RESPONSES TO PEER REVIEW REPORT MOUNT OWEN CONTINUED OPERATIONS PROJECT

The DP&E then commissioned a peer review of the AQIA and RTS report. This peer review was submitted to the DP&E on 30 October 2015 and provided to Pacific Environment for comment on 4 November 2015. A meeting was held at the DP&E on 10 November to discuss and clarify a number of issues raised by DP&E's reviewer. Following this meeting an amended peer review report was issued on 20 November which included revised comments and statements. This document is a response to that amended peer review report issued on 20 November 2015.

Figure 20: Individual contributions to the cumulative annual average PM₁₀ concentrations at R127c, with and without using SX14

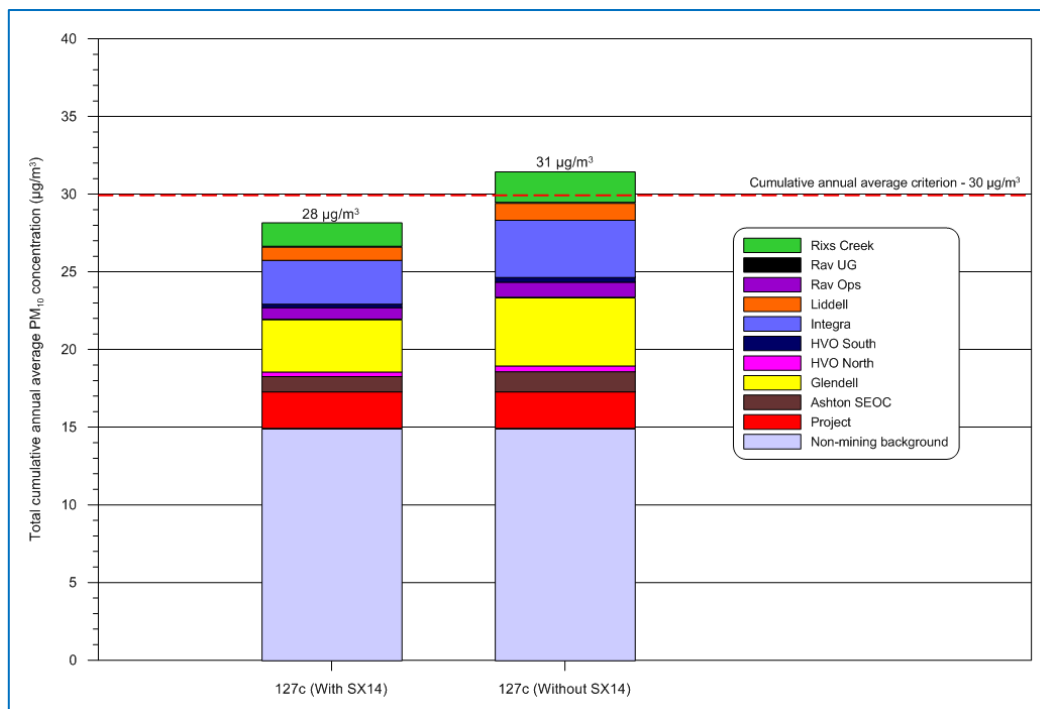
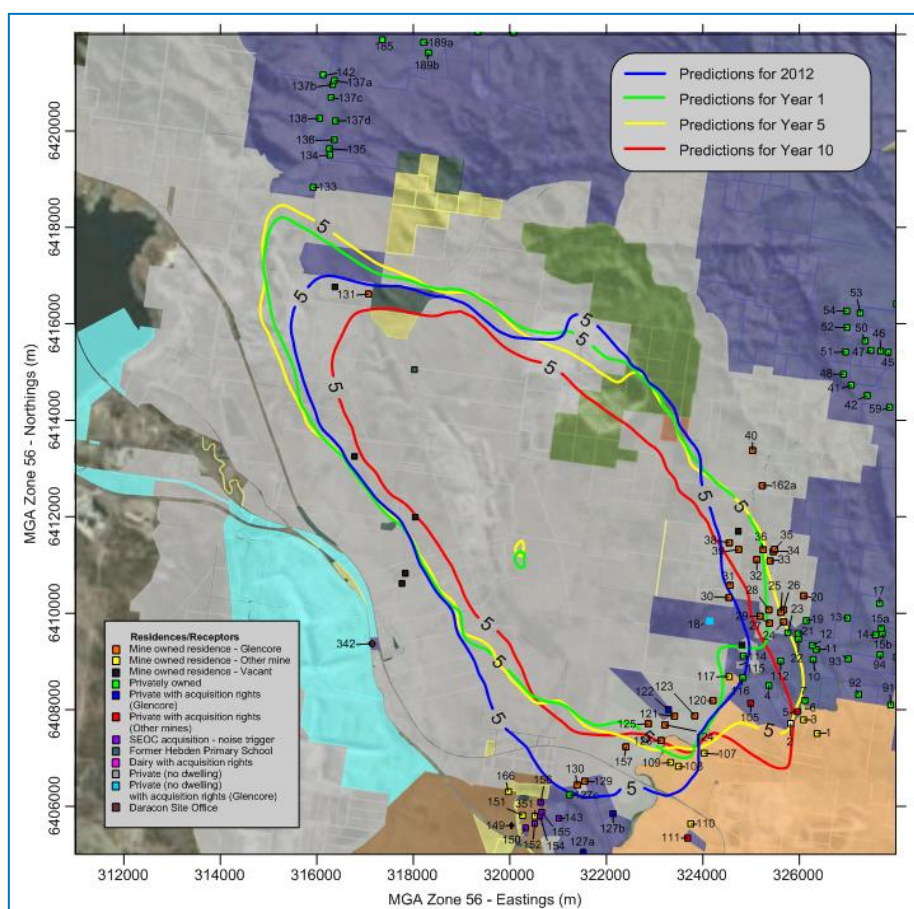
The reviewer is concerned about the use of monitoring data from SX14 and the impact this may have on the calibration factors. As described previously (see response to Peer Review Section 3.6), removing these data from the analysis makes little difference to the calibration grid across the domain, and almost no difference at all in the main area of interest south east of the Project. The only difference from the original AQIA, is a potential exceedance at R127c in Year 1. **Figure 20** presents the individual contributions at this location both with and without SX14 used in the calculations. Using SX14 in the calibration the cumulative annual average PM₁₀ at R127c is estimated to be 28 µg/m³, and 31 µg/m³ when it is removed from the calibration grid.

It is also clear from **Figure 20** that the contributions from both the Project and non-mining background remain the same as they are not calibrated. It is also clear that the Project is not a significant contributor to levels at R127c, and contributes approximately 2 µg/m³ to the total cumulative annual average PM₁₀ predictions.

It is also noted that annual average PM₁₀ concentrations due to operations at Mt Owen are predicted to decrease at R127c with the Project relative to those from existing operations. **Figure 21** shows the predicted levels at R127c due to existing operations are approximately 5 µg/m³, and are estimated to decrease to approximately 2 µg/m³ in future years.

Given that monitoring shows levels near R127c are currently below the assessment criterion² and that levels due to the Project at that location are predicted to decrease from existing levels, it can be concluded that the Project is not likely to be the cause of the modelled exceedances of this criterion at R127c.

Figure 22: Predicted maximum 24-hour average PM_{2.5} concentration (Project only)

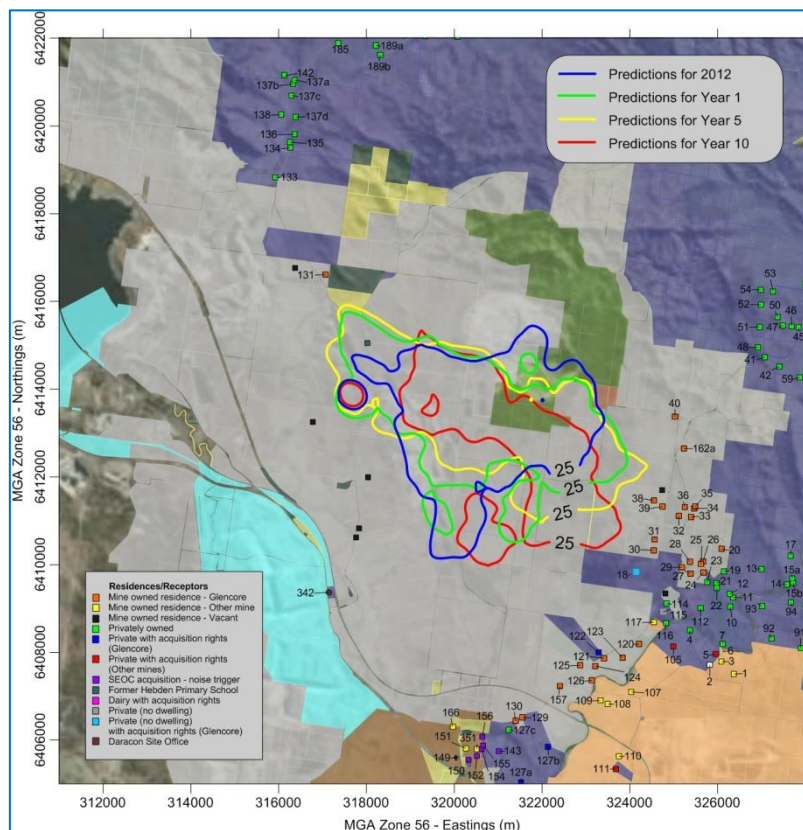
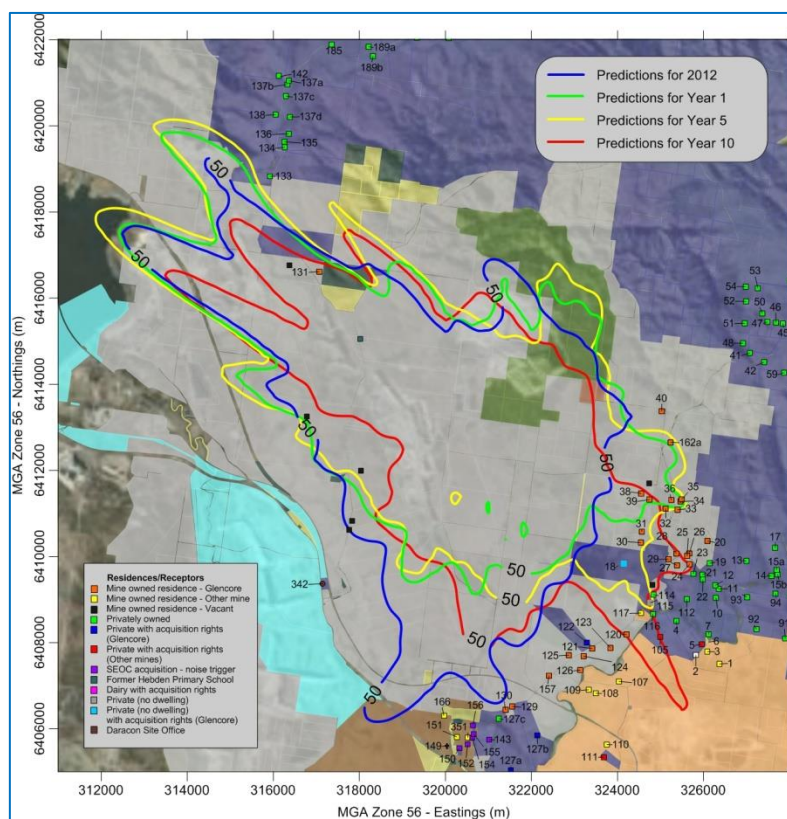
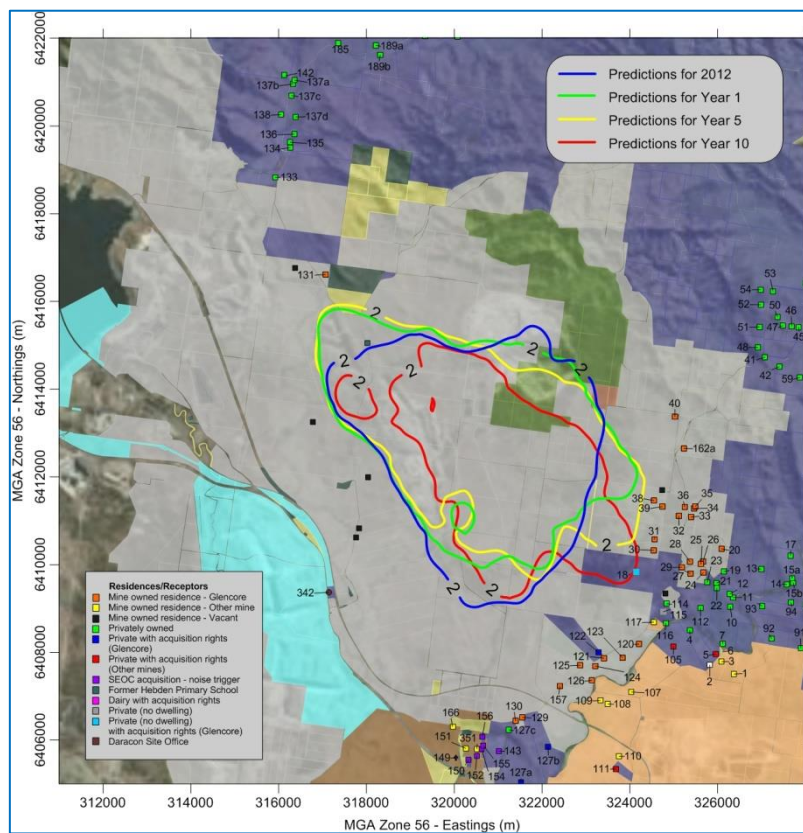
The reviewer also notes that there is no relative comparison between the current and future line of impact. **Figure 22** and **Figure 23** below shows the predicted maximum 24-hour average $\text{PM}_{2.5}$ and PM_{10} concentration (Project only), for Year 1, 5 and 10 relative to the current operations. The same comparison for predicted annual average Project only concentrations are shown in **Figure 24** and **Figure 25** for $\text{PM}_{2.5}$ and PM_{10} , respectively.

As expected, these contours track to the southeast as the Project progresses.
